**RE: FURTHER INFORMATION REQUEST UNDER SECTION 92(1) OF THE RESOURCE MANAGEMENT ACT 1991
PROPOSED OTAIHANGA ESTATES SUBDIVISION**

I refer to your request for further information letter dated 26 July 2021 (RM210147) relating to the proposed subdivision for the Otaihanga Estates located at 48 & 58 Tieko Street; 131, 139 & 147 Otaihanga Road, Paraparaumu.

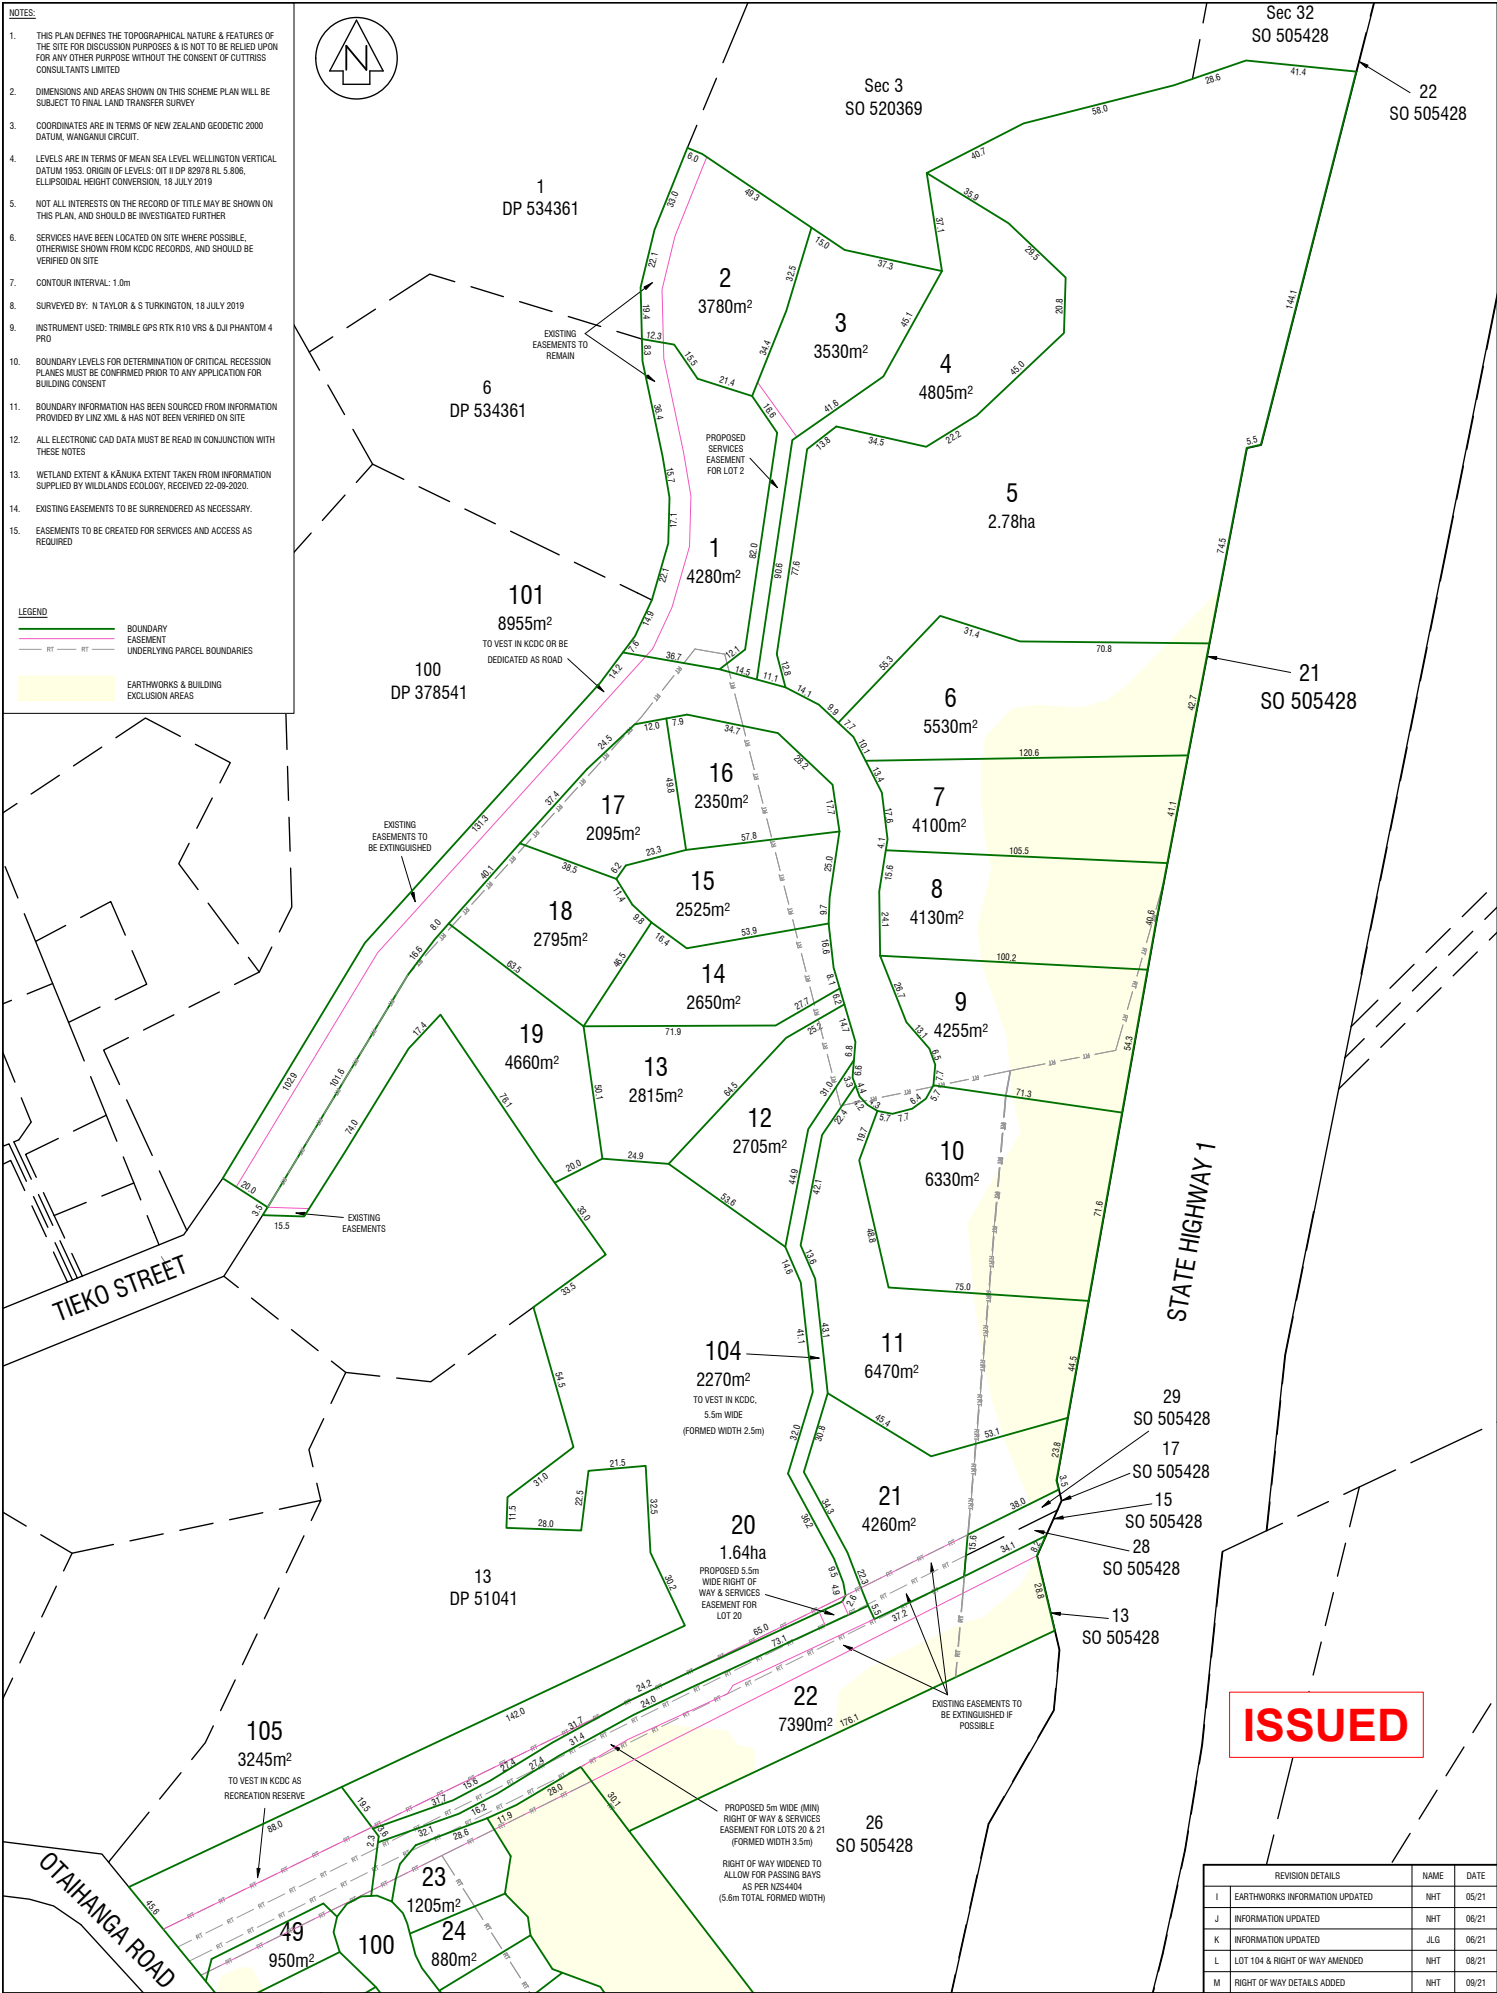
- 11 *The Applicant states that a 2m shared path is proposed, Council minimum standards for shared paths is a minimum of 2.5m width. Applicant to provide amended plans to show this.*

- 13 *All ROW's need to be a minimum of 3.5m wide in accordance with the Operative District Plan 2021.*

- 14 *Can the Applicant confirm that passing bays comply with NZS 4404:2010.*

In response to this point, the applicant can confirm the proposed shared path will be a minimum of 2.5m width. Revised Sheets 8 and 9 of the Scheme Plans 22208 SCH1 in **Attachment 6** show the shared use path (Lot 104) having a legal width of 5.5m, with a formed width of 2.5m along its entirety.

The applicant confirms that the 3.5m wide ROW will be complied with. Revised Sheets 8 and 9 of the Scheme Plans 22208 SCH1 in **Attachment 6** show the 3.5m ROW.

The applicant confirms the spacing and width (5.6m total formed width) of the passing bays are as per NZS 4404:2010. Revised Sheets 8 and 9 of the Scheme Plans 22208 SCH1 in **Attachment 6** that show the complying passing bays.

SCALE A1 - 1:500	REDUCED SCALE A3 - 1:1000
FIELDWORK NHT 07/19	DRAWING NUMBER 22208 SCH
DESIGNED NHT 11/20	SHEET 9 OF 13 SHEETS
DRAWN NHT 11/20	REVISION M
CHECKED NKT 11/20

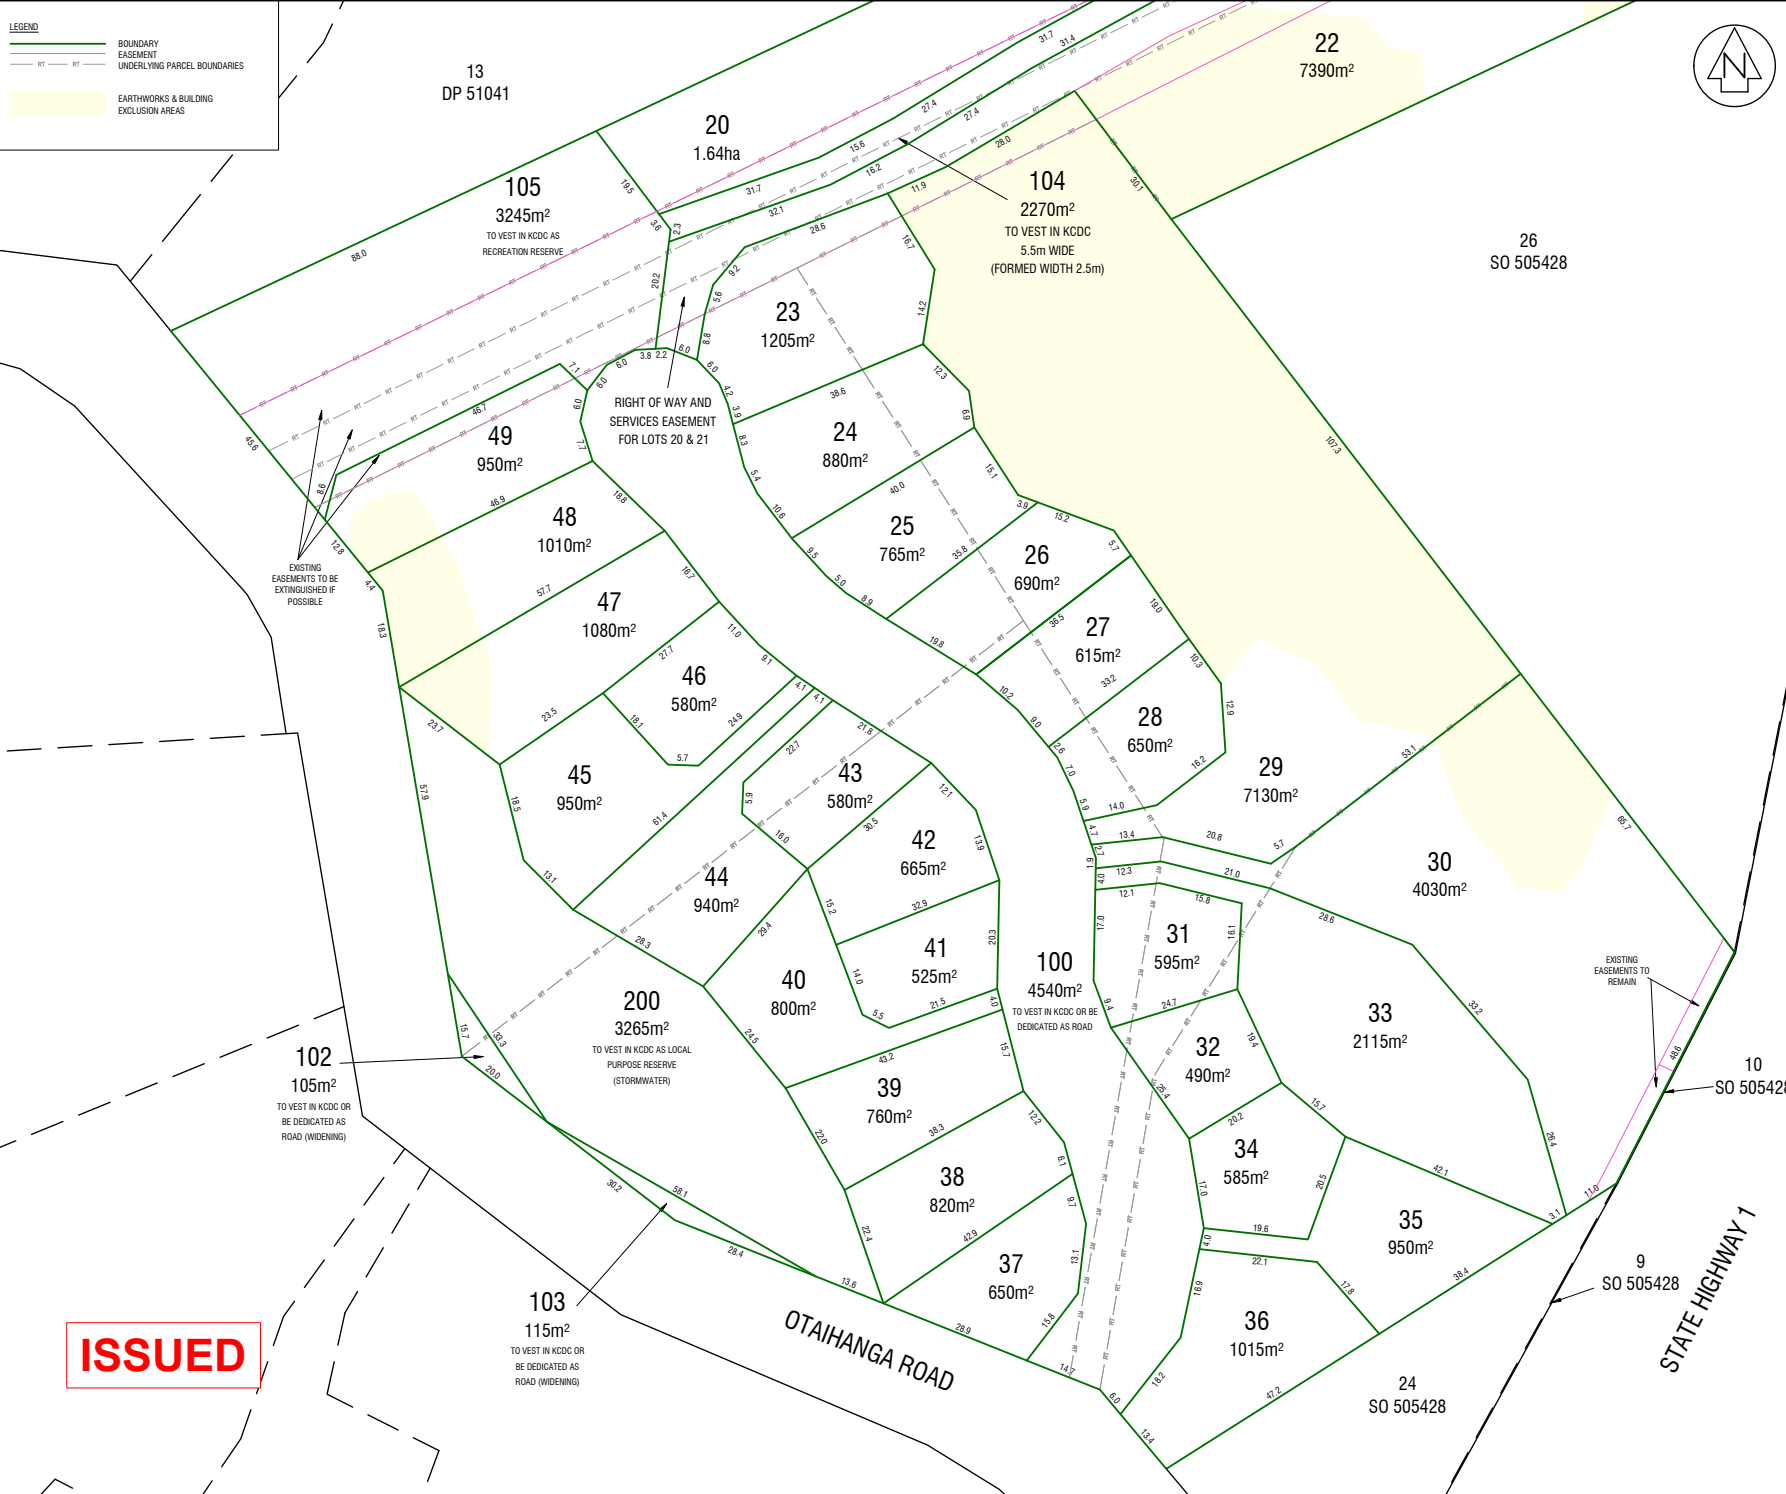
- 12 *Vehicular access over Lot 104 - We have road safety concerns regarding the mixing of traffic and pedestrians/cyclists on a shared path/ROW. Our preference would be to access these lots via access legs to the proposed roads not via the shared path connection. Also, notwithstanding the comments above, the right of way layout raises questions over width, waste collection and delivery vehicle access along with vehicle turning facilities (turning head) and street lighting. Can the Applicant please respond to these issues.*

Following discussions with Council Officers, this concern has been addressed and revised Sheets 8 and 9 of the Scheme Plans 22208 SCH1 in **Attachment 6** show the proposed shared path (legal with 5.5m, formed width 2.5m) alongside and separate to a 3.5m wide vehicle access to Lots 20 and 21. It is considered that this amendment would address the safety concerns raised. Waste collection will be from the cul-de-sac head just as if these properties were urban rear lots. While there is an assumption that turning will be available within the properties which are substantial in size, and two passing bays are proposed as discussed below in relation to #14. It is not proposed to provide lighting along this vehicle access as there is only limited movements to the two sites.

drawing name:
LOT 105 RESERVE PLANTING PLAN

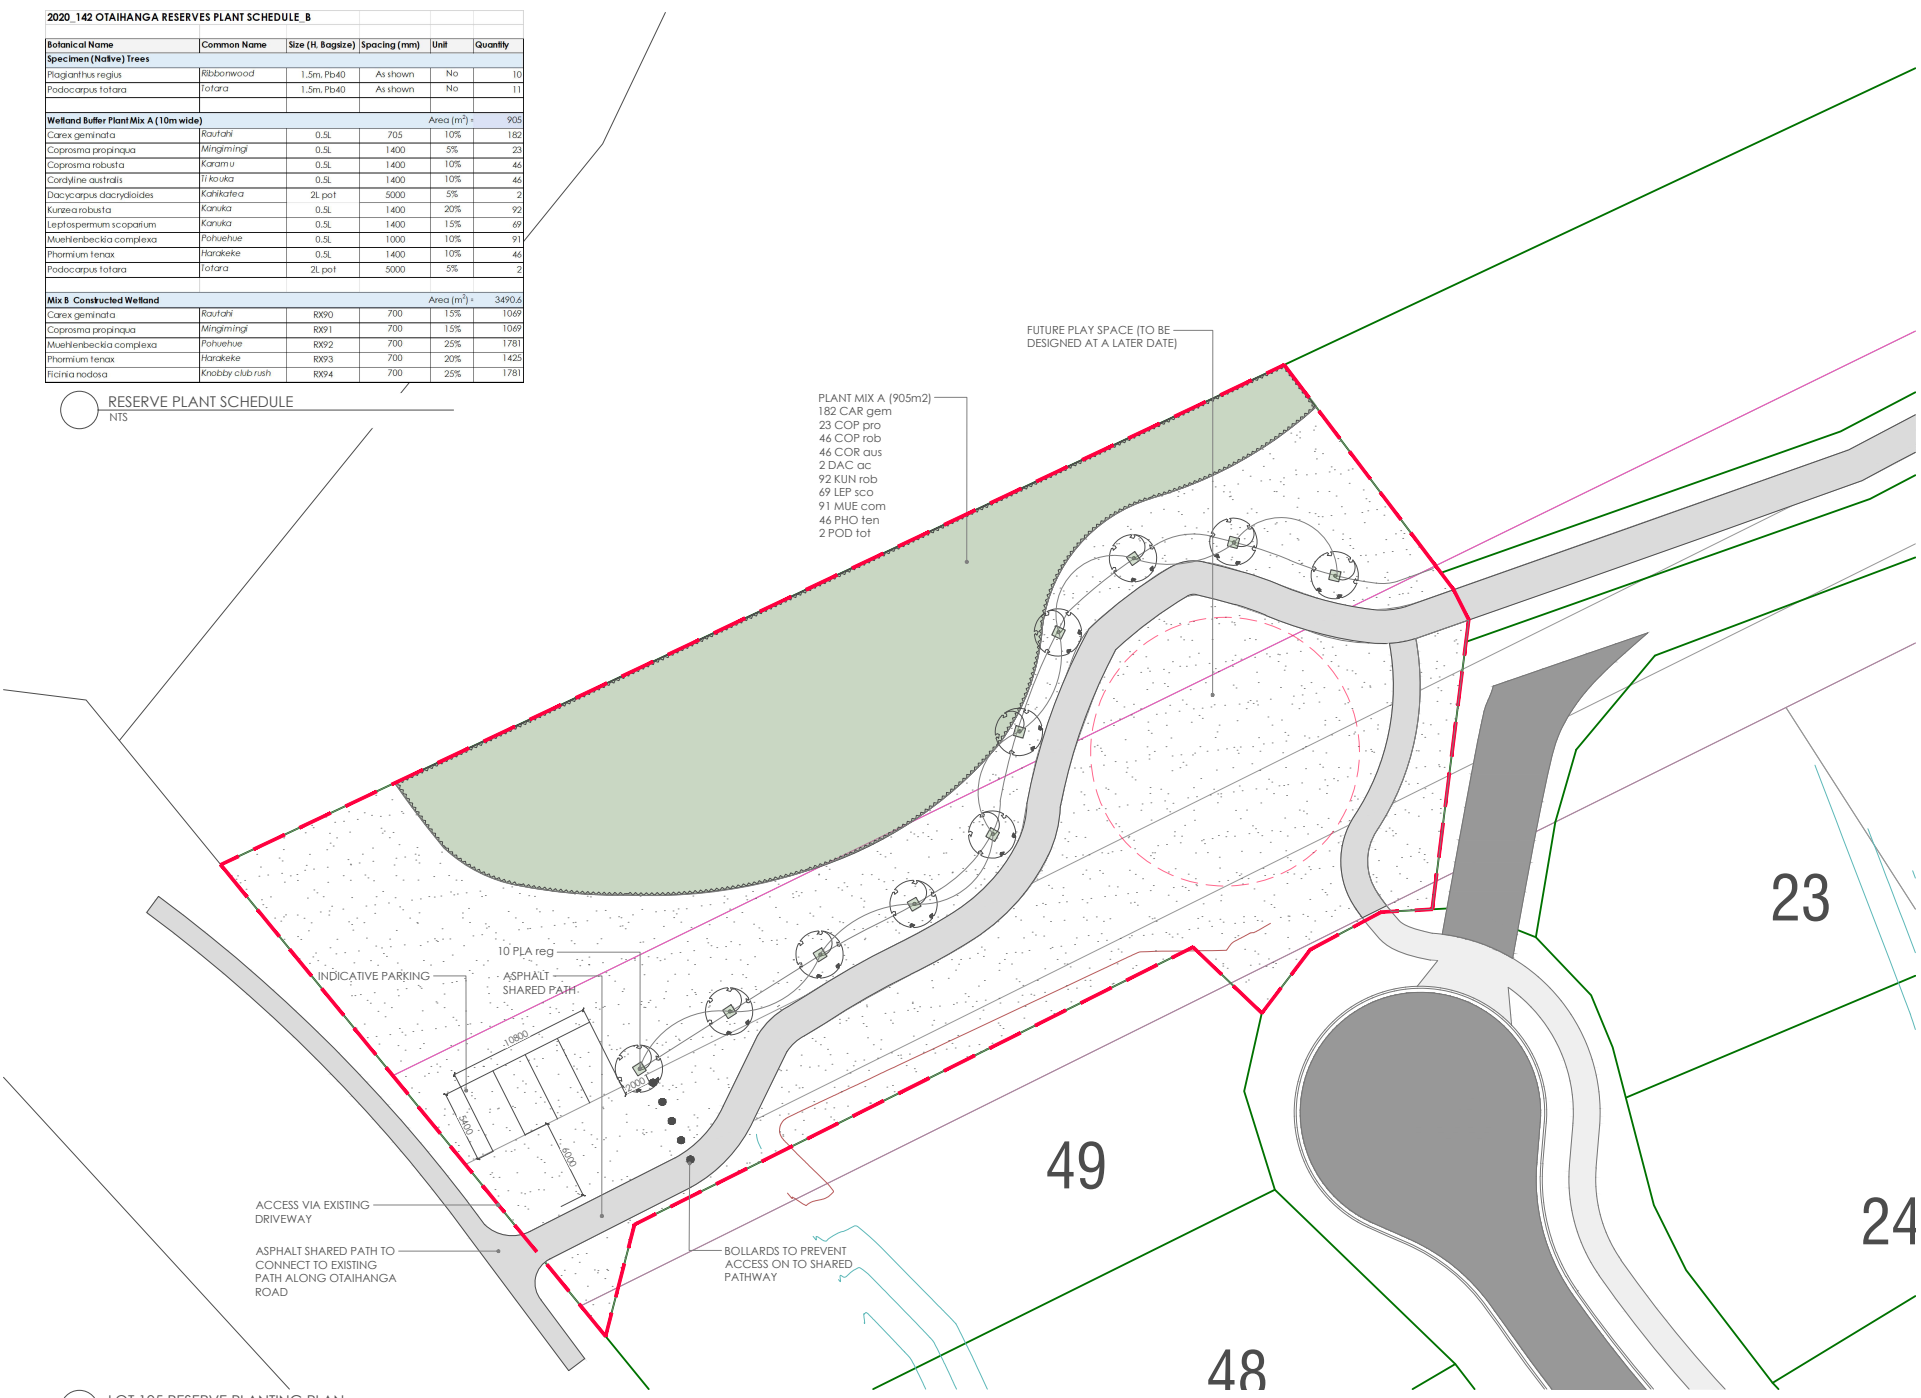
- 22 *The Landscape Concept Plan needs to be updated to show active areas, access, and planting proposed for Lot 105, acknowledging that this will be worked through in detail if the consent is granted.*

A landscape plan in **Attachment 7** shows the active areas, access and planting for proposed Lot 105 and the constructed wetland area. The Applicant's landscape expert has met with Council (Mr Roberts) and has prepared the planting plan based on Council's requirements. By seeking to engage with Council at this time, the Applicant wishes to avoid substantial changes being required by Council to the layout post-consent. Again this work has formed part of the Applicant's developer agreement request and should more properly be considered as part of that process, rather than via a s92 request.
